SUBJECT: CYCLE 11 RELOAD (TAC NO. 67467)

Re: Dresden Nuclear Power Station, Unit No. 3

Amendment No. 94  
License No. DPR-25

ATTACHMENT TO LICENSE AMENDMENT NO. 94

Figure 3.5-1  
(Sheet 2 of 2)

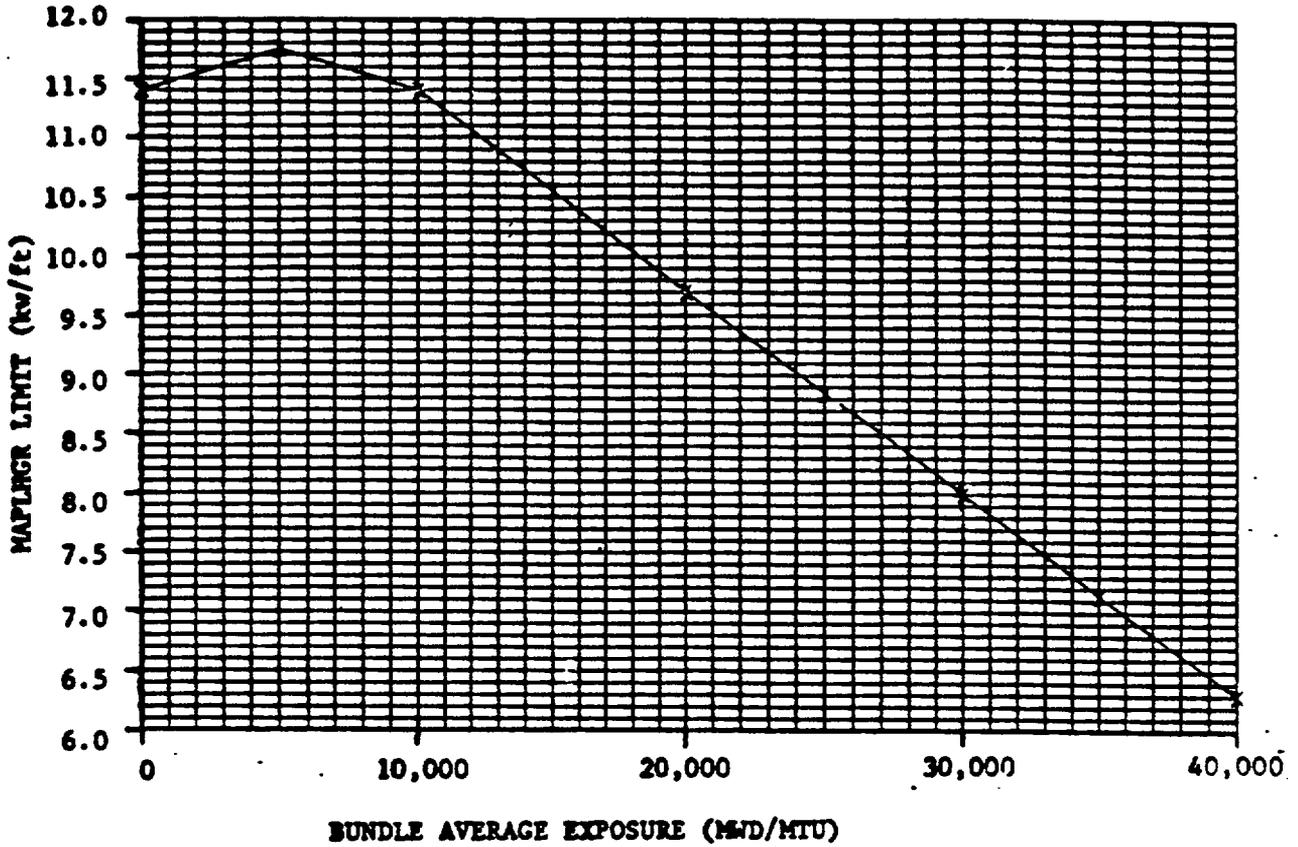
- (7) Specification 3.5.I: Figure 3.5-1 (Sheets 3, 4, and 5) are deleted. These administrative changes are acceptable.

Figure 3.5-1A

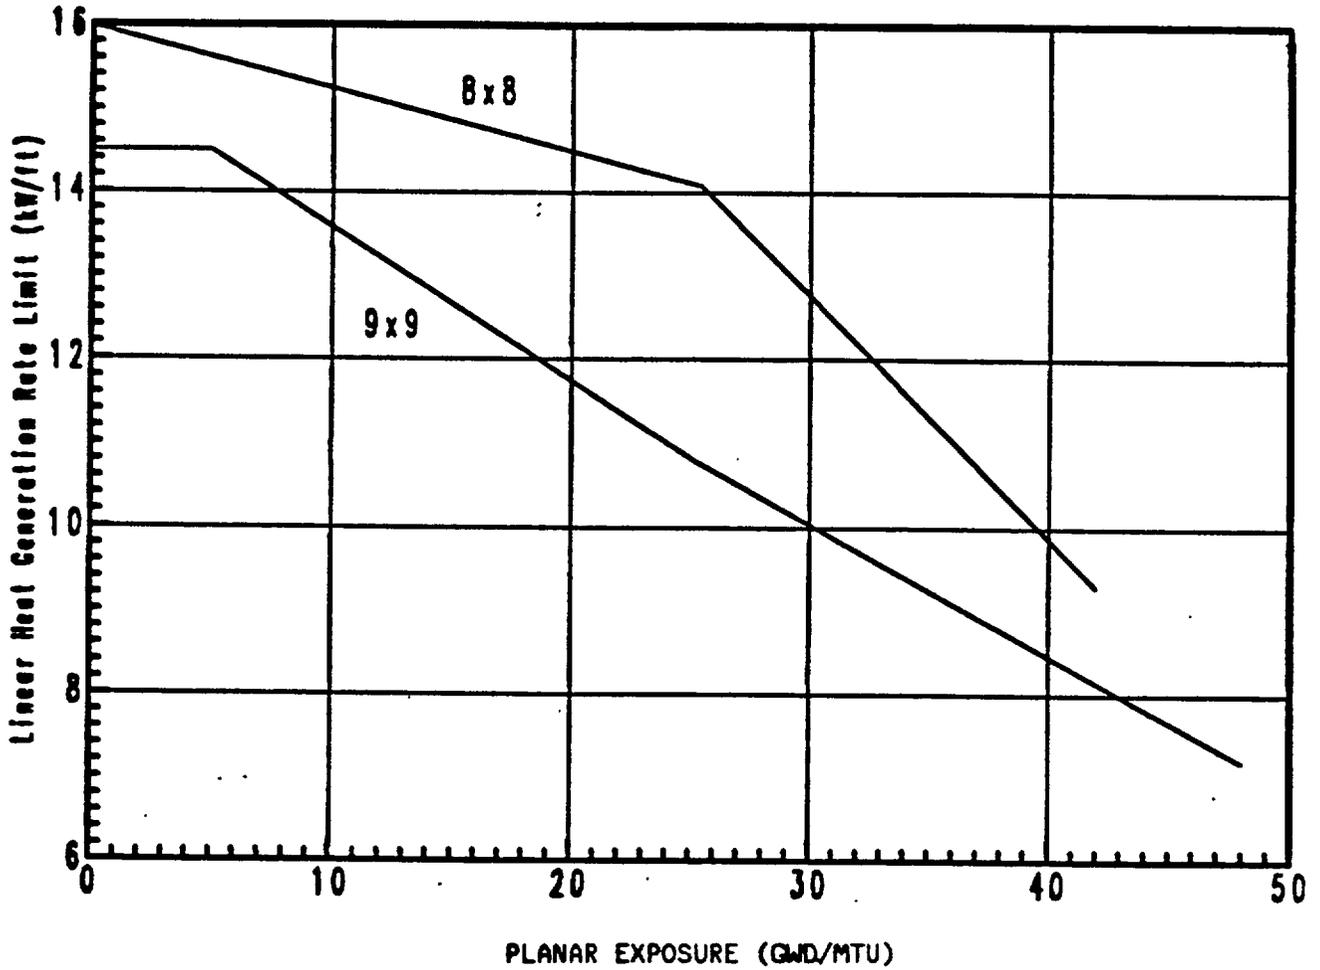
- (8) Specification 3.5.J, 4.5.J: The Section 3.5.J title is changed to "LOCAL STEADY STATE LHGR," references to FDLRX are added, GE LHGR design value of 13.4 KW/ft is deleted from Figure 3.5-1A, and "STEADY STATE" is added to title. These administrative changes are acceptable.

Figure 3.5-1A depicts the SLHGR values for 8x8 and 9x9 fuel as a function of nodal exposure.

Figure 3.5-1B

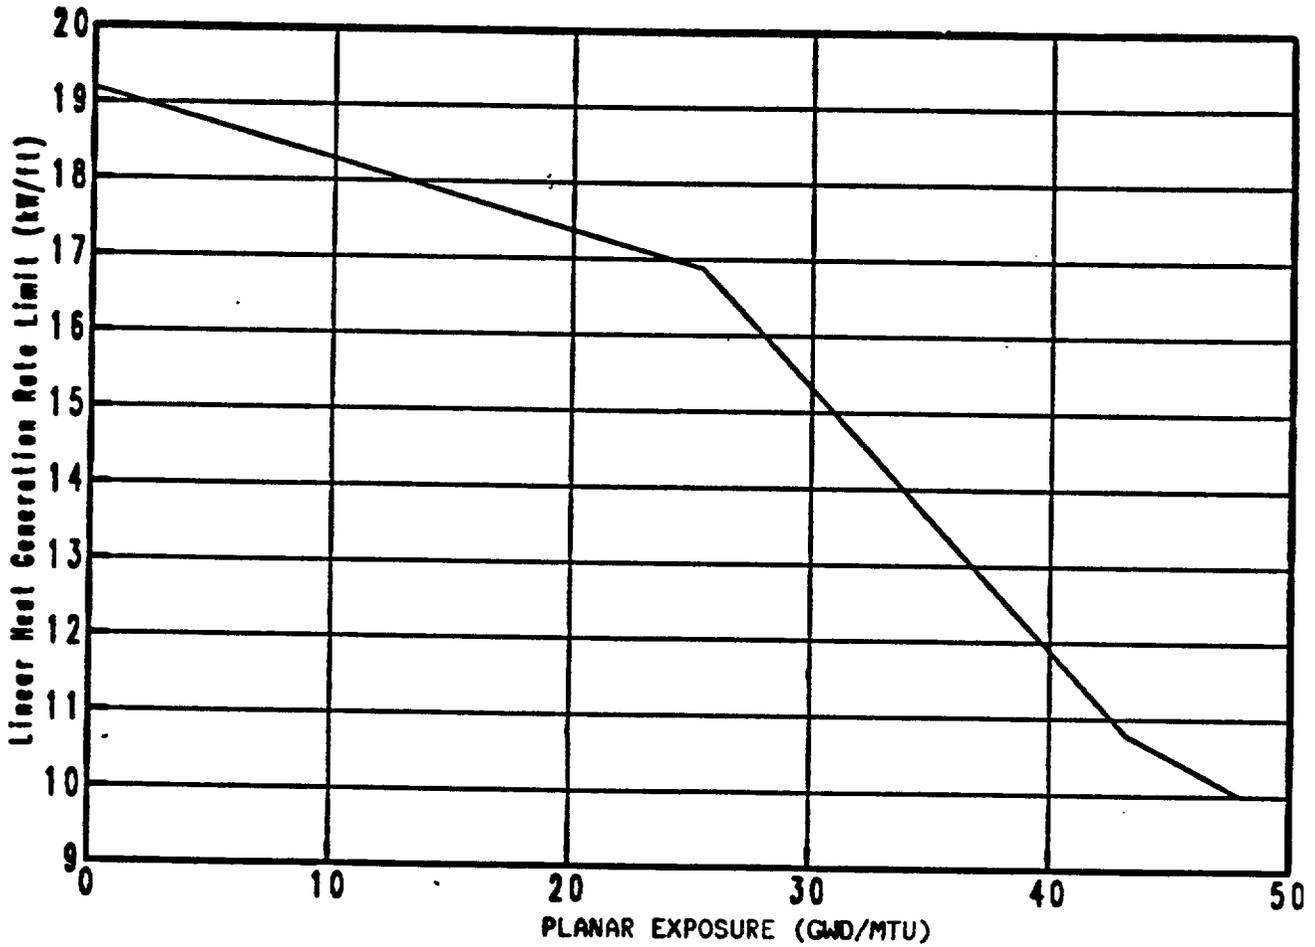
- (9) Specification 3.K.5: A new Section on local transient LHGR and FDLRC is added as well as Figure 3.5-1B showing the Transient LHGR Limit curve. These administrative changes are acceptable.

Figure 3.5-1B depicts the TLHGR values for 8x8 and 9x9 fuel as a function of nodal exposure.

Figure 3.5-2 (Sheet 1 of 3)  
 MCPR Limit for reduced Total Core Flow

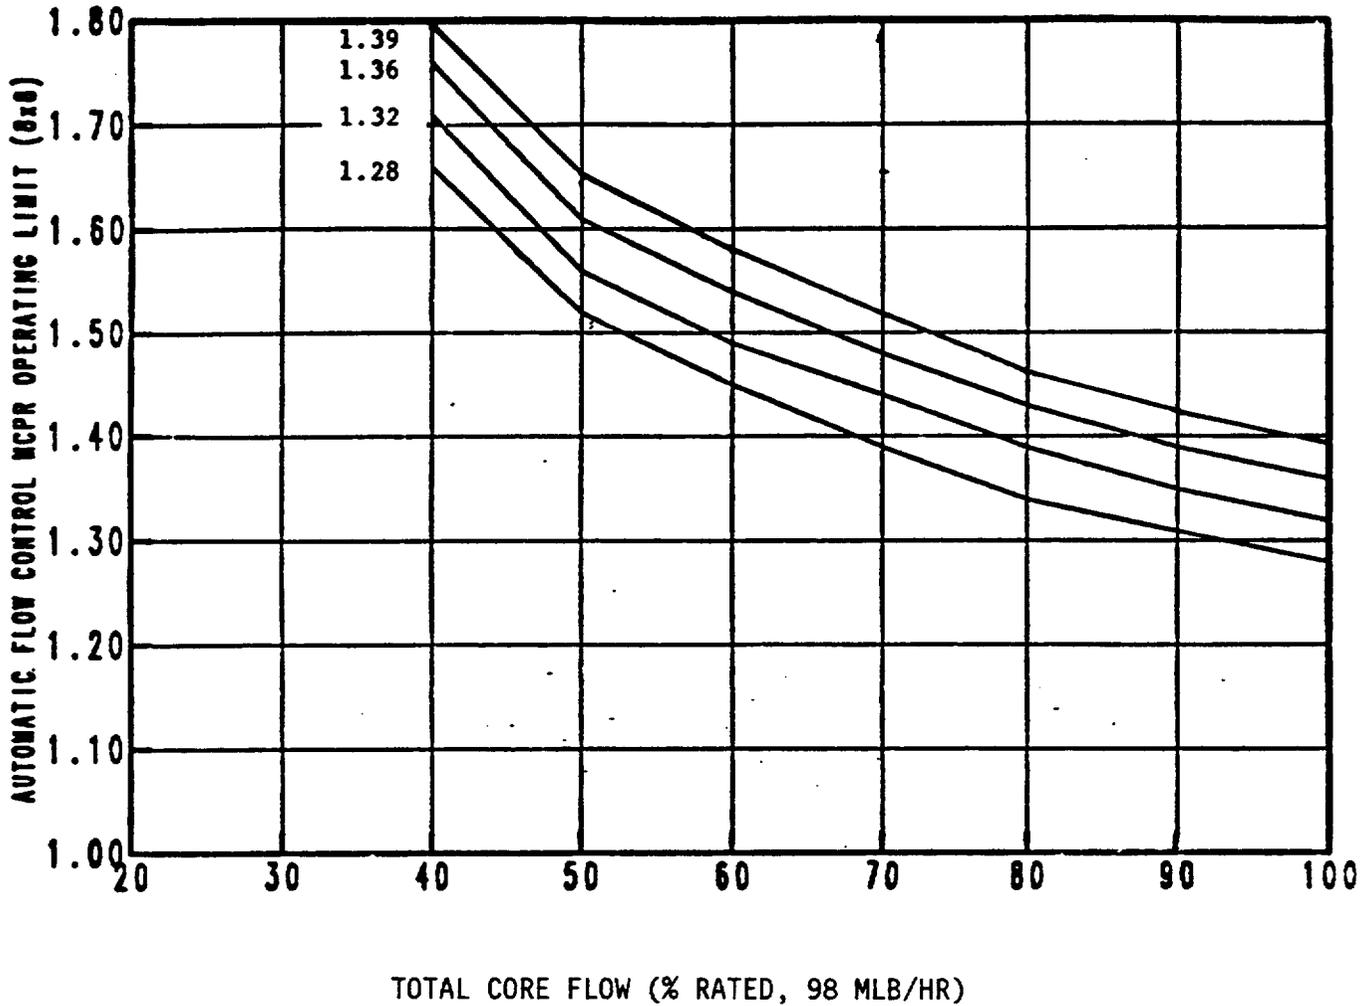
- (4) Specification 3.5.L.1 and Figure 3.5-2: The Figure (Sheets 1, 2, and 3) is revised to incorporate changes in reduced flow MCPR values. This has been evaluated in Section 2.5 and found to be acceptable.

Total Core Flow (% Rated)	MCPR Limit	
	8x8	9x9
100	1.10	1.09
90	1.15	1.14
80	1.21	1.20
70	1.28	1.26
60	1.36	1.34
50	1.46	1.44
40	1.60	1.57
